PCII Request / Re-assessment

< ME909u-523D >, FCC ID: < QISME909u-523 > granted on < 2014-4-15 >

Differences between the ME909u-523(LGA) and the ME909u-523D(LGA)

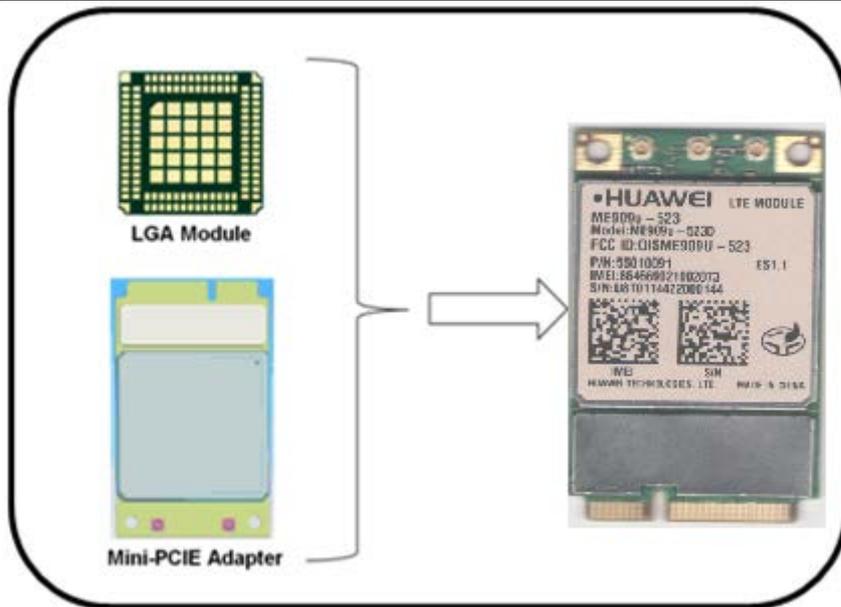
The name of ME909u-523(LGA) module has been changed to ME909u-523D(LGA). And the LTE B13, LTE B25, LTE B26 have been disable in software, so the ME909u-523D(LGA) will not support the LTE B13, LTE B25, LTE B26. The hardware of ME909u-523(LGA) and ME909u-523D(LGA) is same. So the name of ME909u-523(LGA) module make change class I.

There is the same hardware and software between the ME909u-523D(LGA)and the ME909u-523D (PCIE). The only interface changes from LGA to PCIE.

The differences between the ME909u-523(LGA) ,the ME909u-523D(LGA) and the ME909u-523D(PCIE) have been listed in following table:
